NORTHERN WOLVES
AIR CONDITIONING

Project: **Sunrise Rye Brook - Independent Living / Assisted Living**

Mechanical drawings dated: 07.15.2026 (GMP set)

Mechanical Value Engineering Proposals

VE-01 Heating plant: delete boilers and hot water / glycol systems

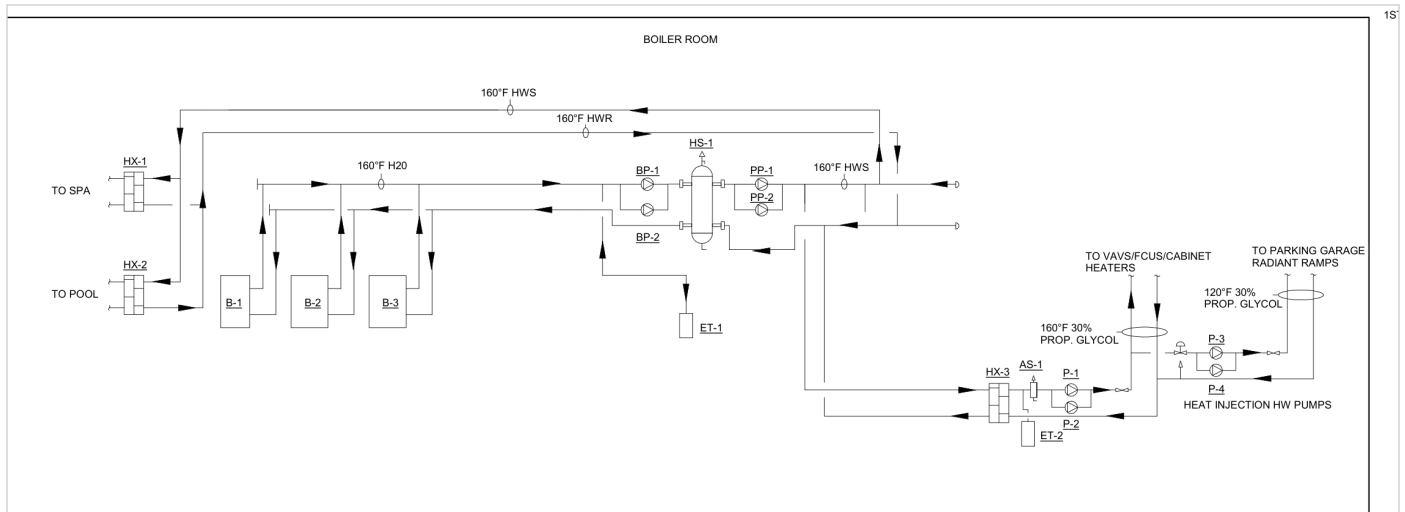
- Three 1,999 MBH gas boilers B-1, B-2, B-3 (5,700 MBH output), primary / secondary with HS-1
- Pumps BP-1/2, PP-1/2, P-1 to P-4, expansion tanks ET-1/2, air separator AS-1, heat exchanger HX-3 to 30% glycol
- Fire-rated chimney enclosures basement to roof, combustion air areaway, water treatment, hot water and glycol distribution to the 1st floor and basement
- Connected heating load about 2,430 MBH: the plant is about 2.3 times the load

- Delete the boiler plant and all hot water / glycol distribution; the building runs on gas rooftop units, heat pump DOAS and the electric terminal heat in VE-02 to VE-06
- No boiler room equipment, chimneys, combustion air, water treatment, flushing or hydronic balancing
- Pool and spa heating by the pool contractor (by others)

Approvals / coordination: Requires VE-02 to VE-06. IMEG redesign; Sunrise approval.

VE-02 VAV reheat: hot water coils to electric reheat

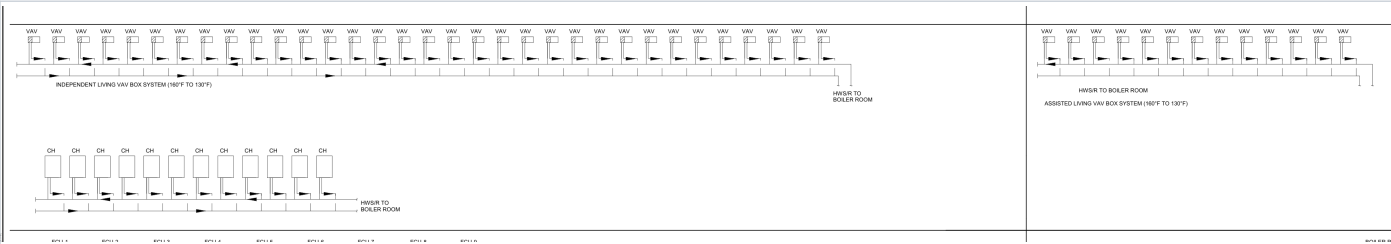
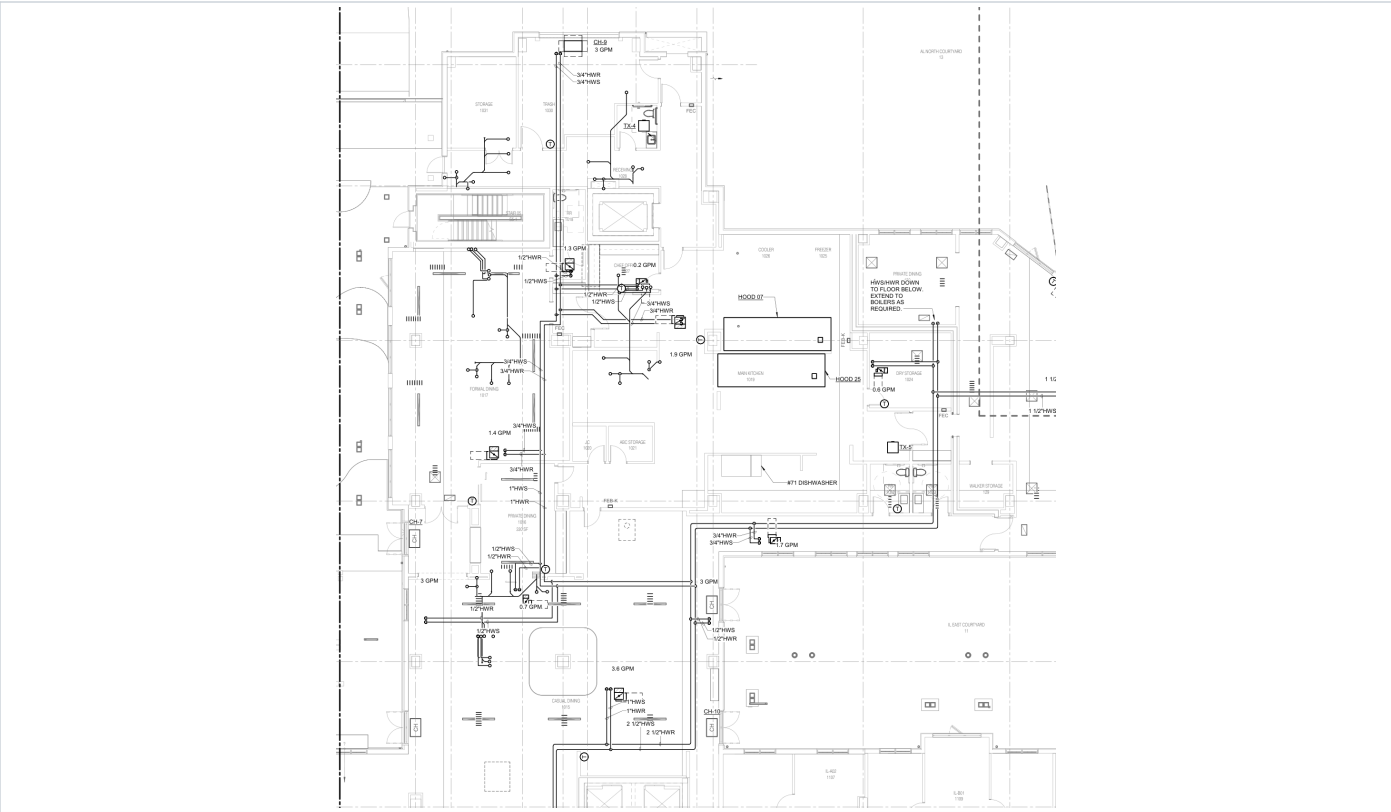
- 47 VAV boxes with hot water reheat coils (629 MBH, 45 GPM) on 5 rooftop units
- Hot water piping, control valves, balancing and insulation to every box (M2014 to M2016)

- Factory electric reheat coils with SCR control on the same VAV boxes; no piping, no control valves
- IMEG to confirm which interior zones need reheat at all (rooftop units already supply gas-heated air); cooling-only boxes where reheat is not required

Approvals / coordination: IMEG redesign and energy code check (VAV minimums); electrical service capacity by EE.

M2011 1st floor ductwork - VAV boxes and cabinet heaters in dining / kitchen area

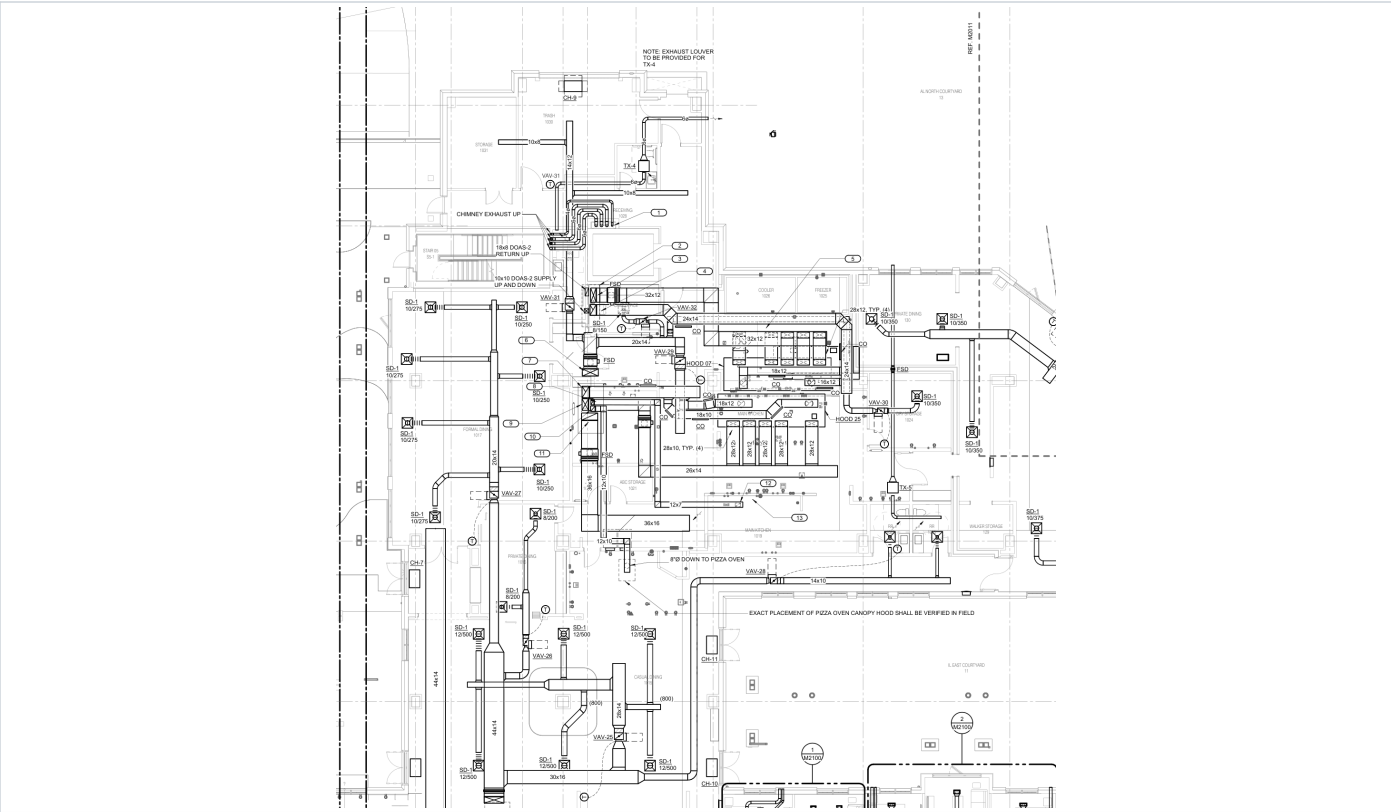
- 5 large VAV rooftop units (7,000 to 11,000 CFM) serving 47 VAV zones with reheat

- Large open spaces on single-zone constant-volume gas / DX rooftop units, one per space type
- Offices and small rooms on ductless heat pumps; delete the VAV boxes and reheat
- Ductless units recirculate only: each small room keeps a ventilation air branch (code outdoor air) with a diffuser, preferably tempered air from the DOAS (or a small ERV per room cluster), not raw rooftop unit supply air that would fight the ductless unit
- Same approach as other recent Sunrise communities (e.g. Sunrise of Northport: small single-zone rooftop units plus heat pump terminals, no VAV, no boilers)

Approvals / coordination: IMEG zoning concept, ventilation air source and redesign; Sunrise approval.

M2011 1st floor - CH-7, CH-9, CH-10, CH-11 locations

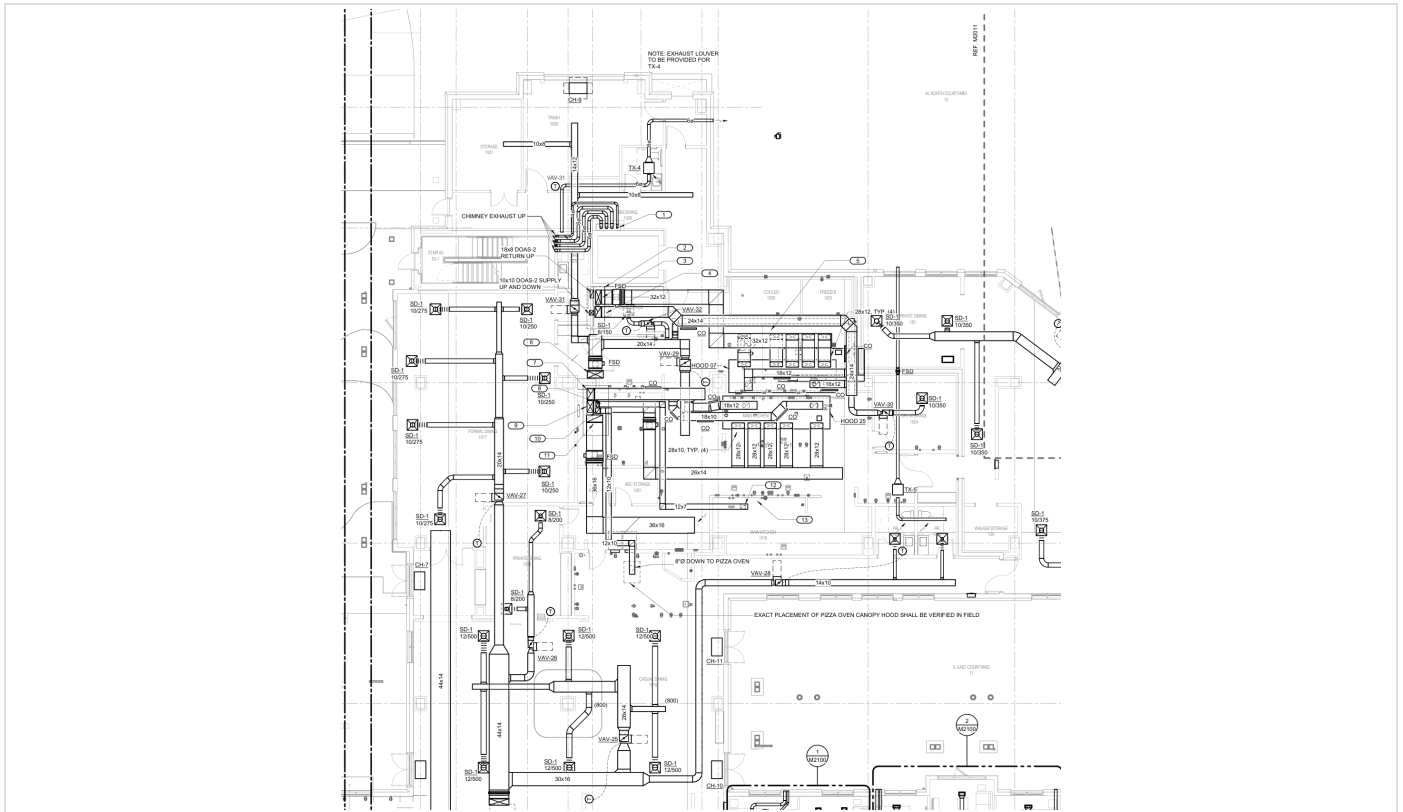
- 12 hot water cabinet heaters (234 MBH) with piping and BMS control

- Electric cabinet heaters with integral thermostats, no piping, no BMS points

Approvals / coordination: IMEG; EE.

VE-05 Basement back-of-house fan coil units

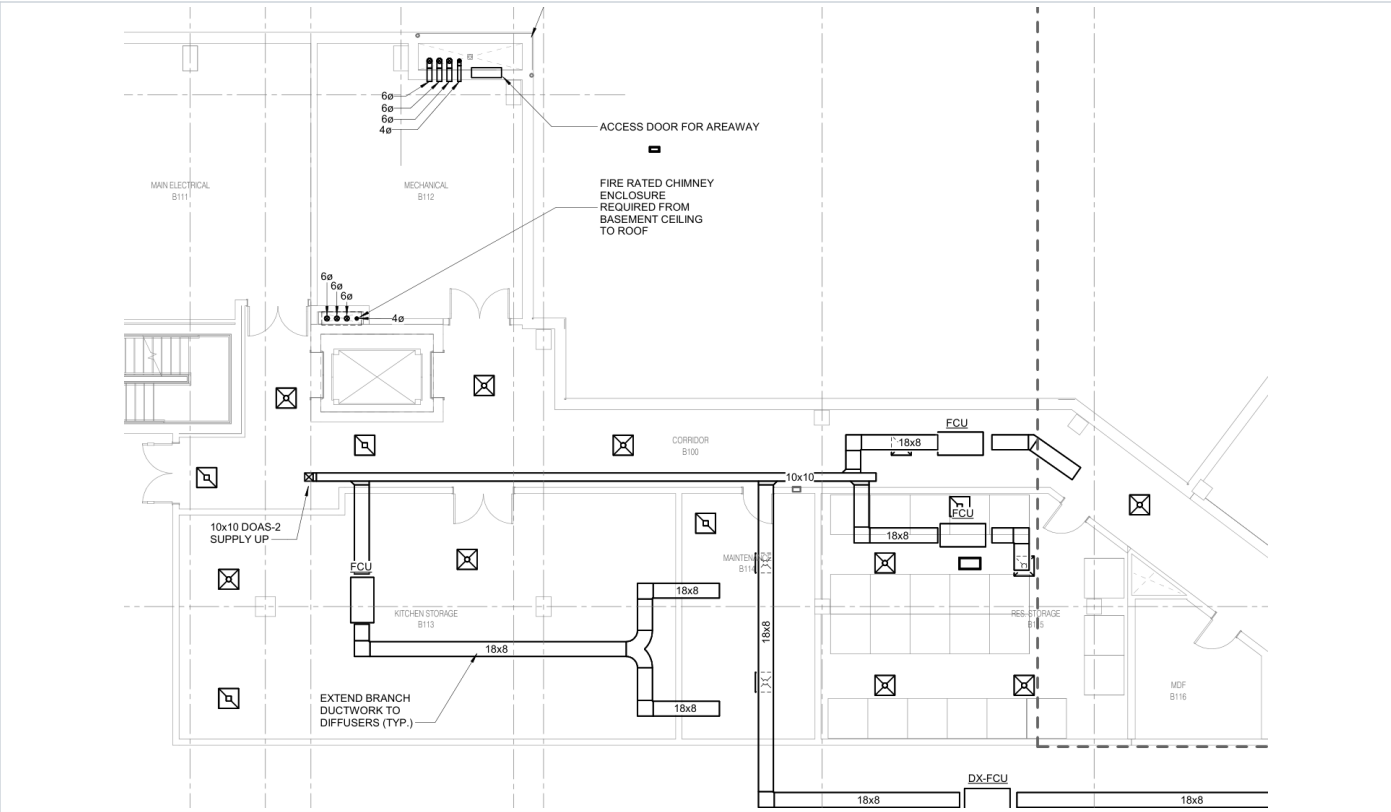
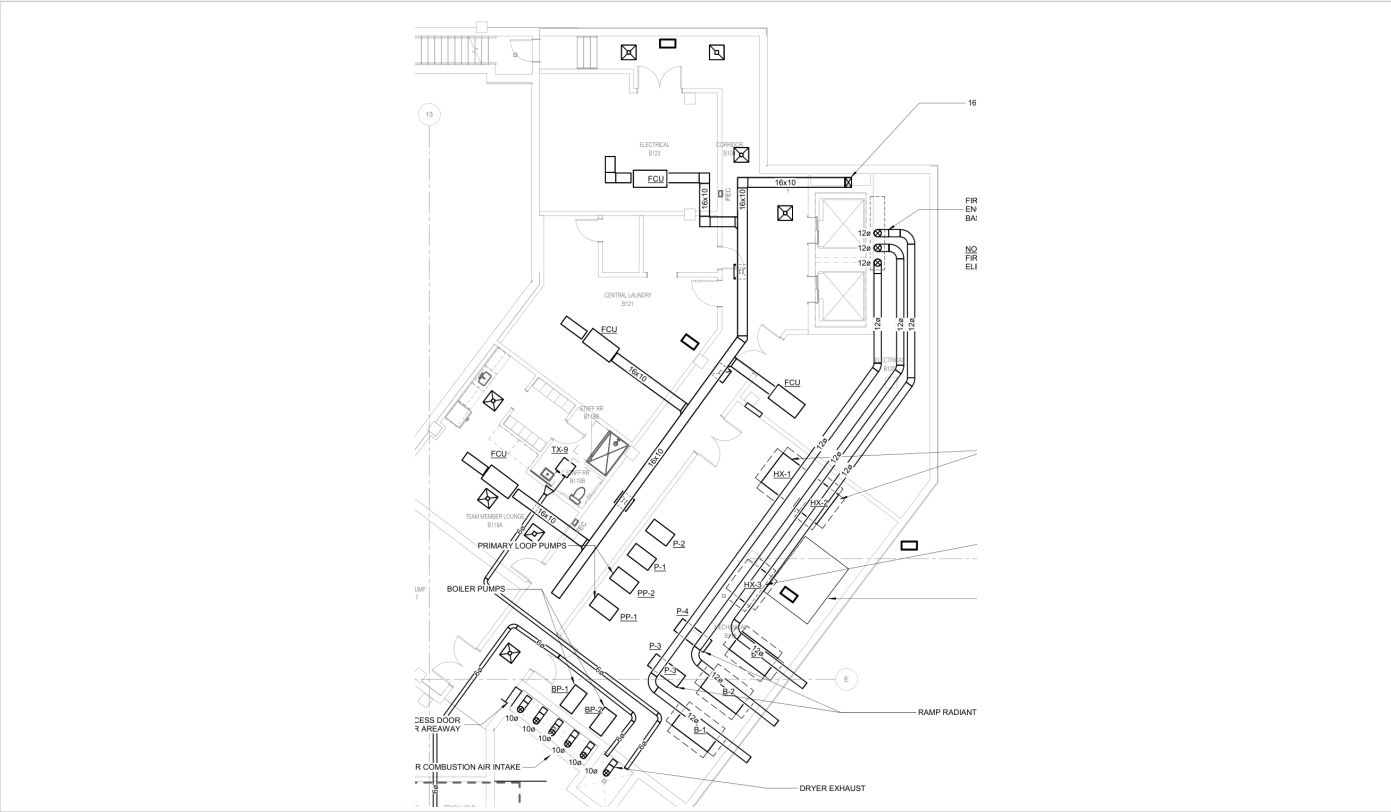
- FCU-A, quantity 20, "basement heating", hot water / glycol heating coil only (schedule data blank); M5000 shows FCU-1 to FCU-17 on the glycol loop with RAD-1/2
- Each FCU takes a small DOAS branch at its inlet and recirculates the room (booster fan plus reheat)
- No glycol or hot water piping to these units is drawn on M2001 / M2003

- Delete the 20 FCUs and RAD-1/2; extend the DOAS branch ducts directly to the room diffusers
- Electric unit / wall heaters with integral thermostats only where there is freeze risk (trash rooms, rooms at areaways, louvers or exterior walls)
- Occupied rooms (staff lounge, corridor) on a small ductless heat pump or duct heater
- Electrical rooms, MDF and laundry need cooling and ventilation, not heat: ductless AC for MDF and electrical rooms, thermostatic exhaust / make-up for laundry (not on the drawings today)

Approvals / coordination: IMEG; fire protection designer to confirm freeze-protection locations.

M5000 Hydronic flow diagram - basement FCUs, RAD-1/2 and ramp snow melt loops

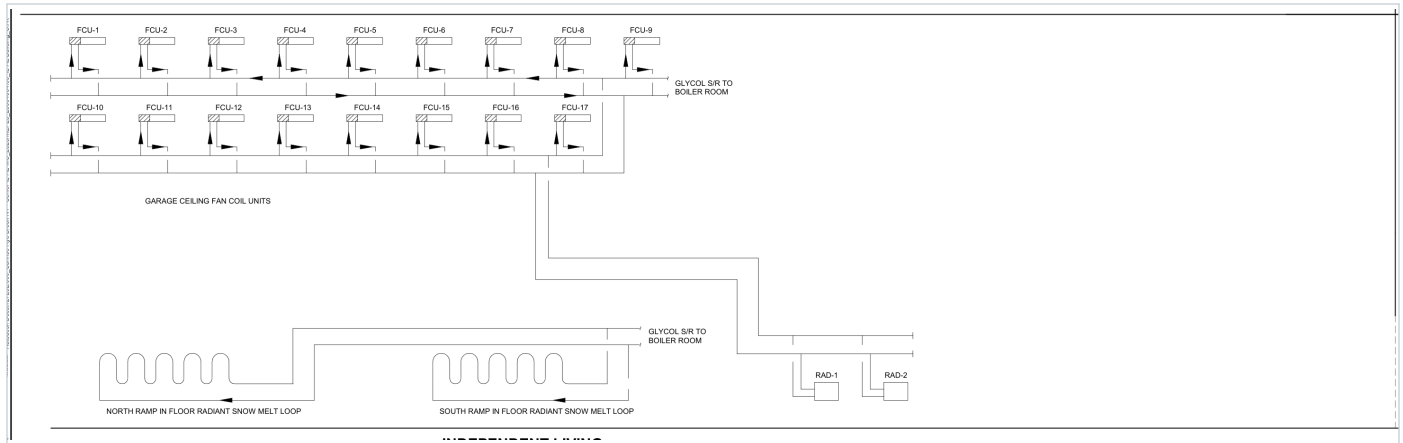
- In-floor radiant snow melt loops on both ramps from the boiler plant through HX-3

- Option A: no snow melt; trench drains and salting (owner decision)
- Option B: electric snow melt cable by EC, storm-only operation with load shedding

Approvals / coordination: Owner decision; civil / landscape for drainage.

M2023 AL 2nd floor - DOAS corridor ducts, FSD at shaft and note for all units

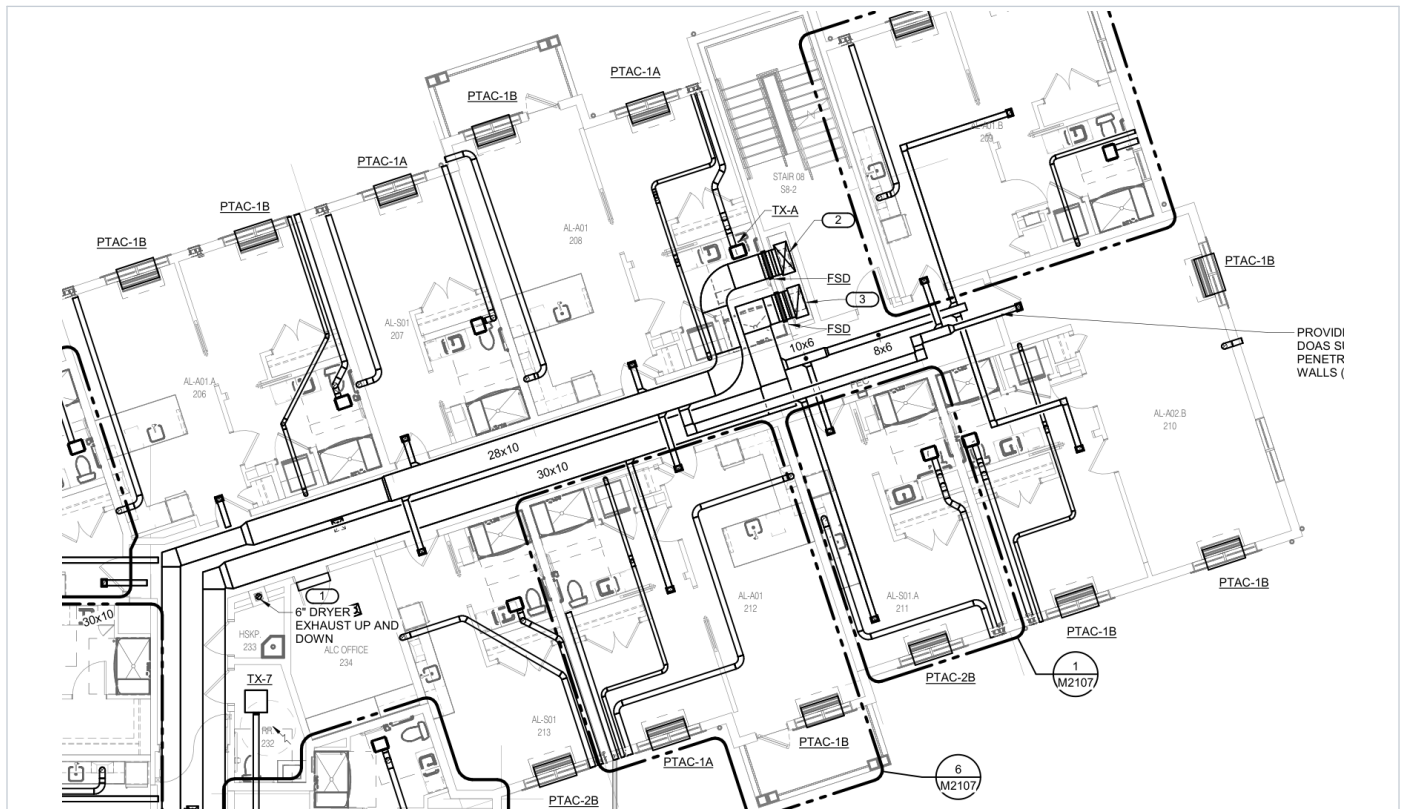
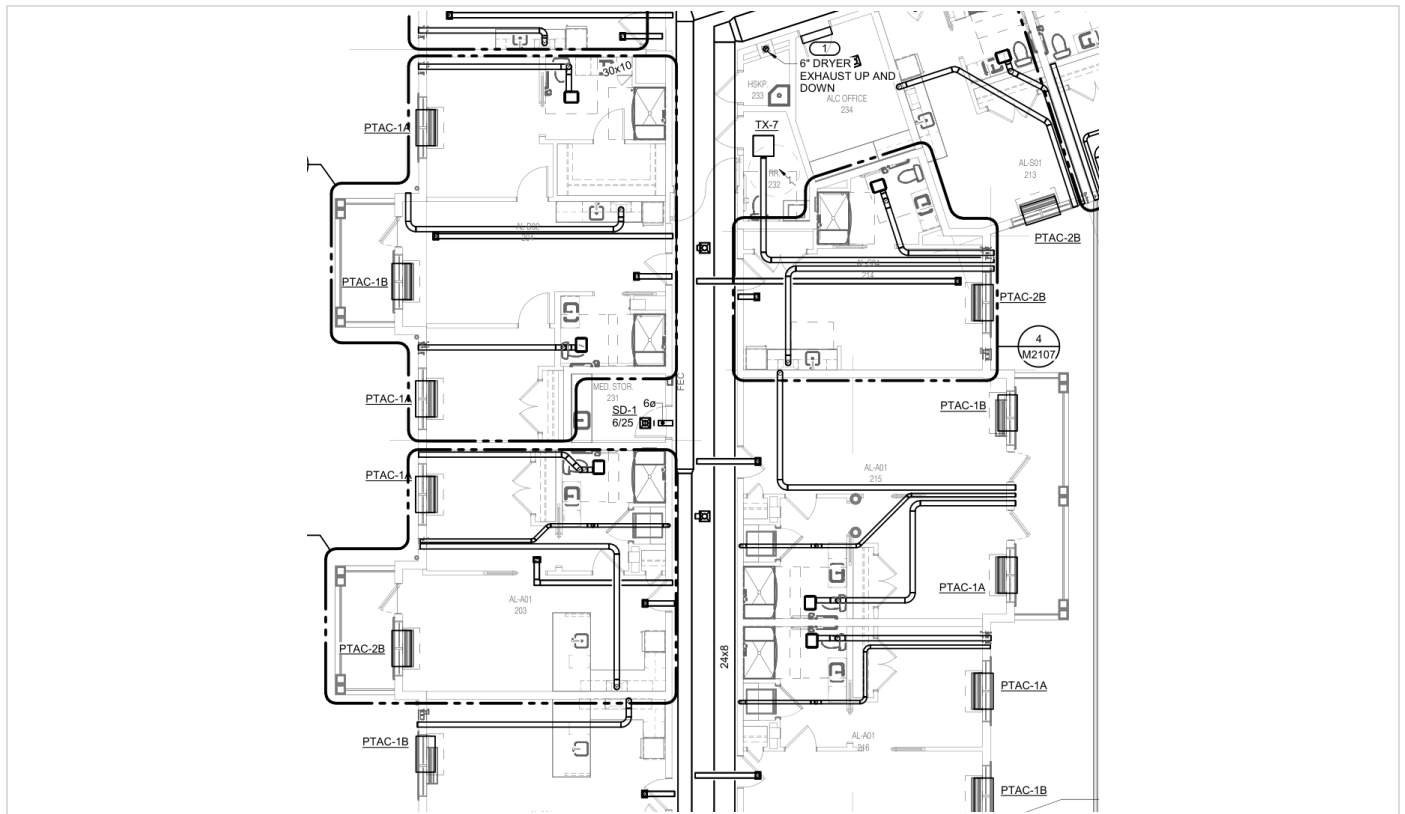
- Combination fire / smoke damper at every DOAS supply / return branch into each apartment (M2023 note: "provide fire/smoke damper at all DOAS supply/return penetrations through demising walls")
- Each damper needs power, fire alarm interface, access door in a finished ceiling and periodic testing

- Apartment branches (6x4 to 8x6) under 100 sq in, 26 ga steel, no openings into the corridor, above the ceiling, with 12" steel sleeve: no damper required at the corridor fire partition (IBC 717.5.4 exception); plain fire dampers as fallback
- Fire / smoke dampers kept at shafts and smoke barriers

Approvals / coordination: IMEG / HKS code analysis (AL Group I-1 smoke barriers), building department.

M5000 - BMS-controlled hydronic terminals eliminated by VE-01 to VE-05

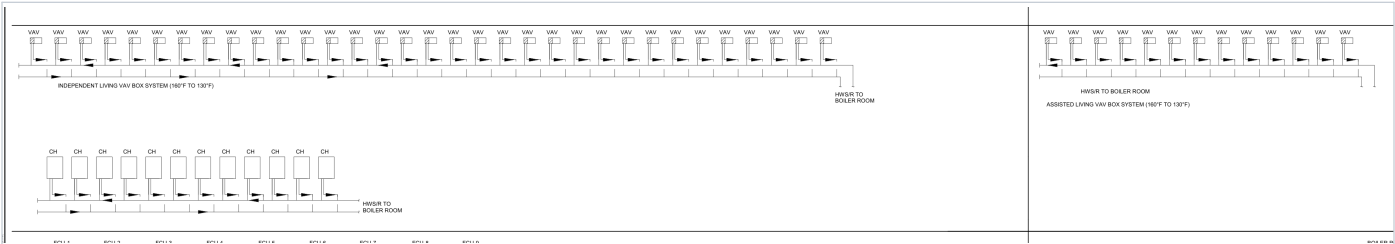
- Full BMS by the BMS contractor for boilers, pumps, heat exchangers, glycol, snow melt, VAV reheat, FCUs, cabinet heaters, rooftop units and DOAS

- With VE-01 to VE-06 the hydronic sequences (about 120 to 150 points) are gone
- Rooftop units and DOAS on their factory controls with network cards for future monitoring; heaters, mini-splits and PTACs on standalone thermostats (as on other Sunrise communities)

Approvals / coordination: Sunrise approval of the controls standard.
